**Re: Rezoning and Major Site Plan Application**  
**Property: 3421, 3415, 3411 Washington Blvd.; 1122 N Kirkwood Rd.**  
**RPC# 15-086-006, 005, 002, 025, 001**  
**Contract Owner/Applicant: Eleventh Street Development, LLC**

Please find enclosed the resubmission of an Administrative Regulation 4.1 major site plan application and a resubmission of the rezoning application for the above-referenced Property.

## Conceptual Site Plan Review Report

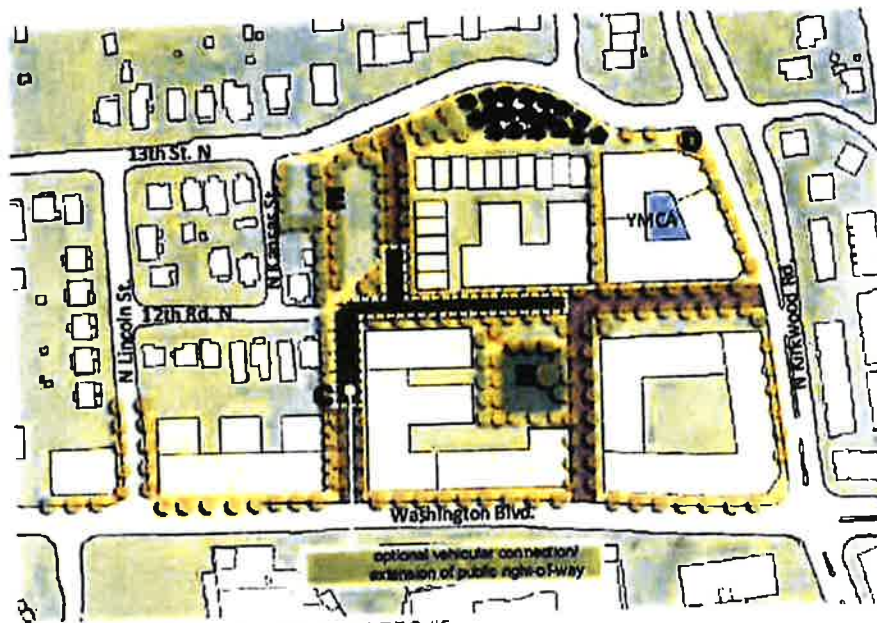
- The applicant requests a modification allowing for an additional 56 residential units. The applicant should demonstrate how the bonus density is being earned.
- The next submission should elaborate on the “potential rooftop amenities” shown on Sheet P-04.
